**Supercharged Engine (W5A580 Transmission)
– Oil Seepage From Electrical Connector
– Repair Procedure**

MODEL 1998 MY-ON
V8 XJR

VIN 812256-ON

ILLUSTRATION 1

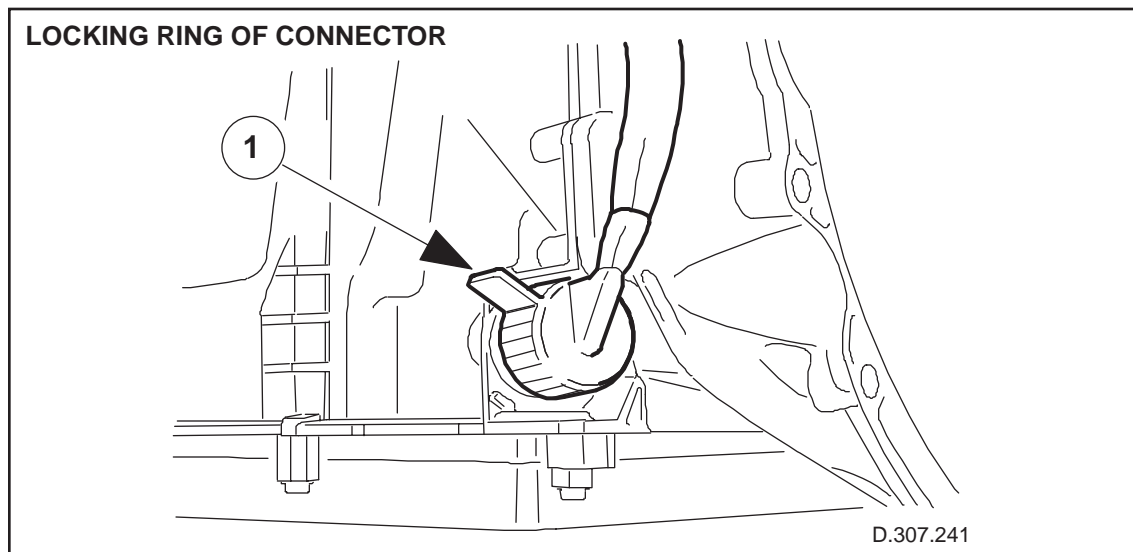
3. Place a new seal on the drain-plug and reinstall and torque the drain-plug to 22 Nm (16.2 lb. ft.).
4. On the right side of the transmission, remove the bolt that retains the heat shield for the multiplug connector. Remove the heat shield.
5. Rotate the lock ring counterclockwise to release the multiplug connector (Illustration 1). Disconnect the multiplug.
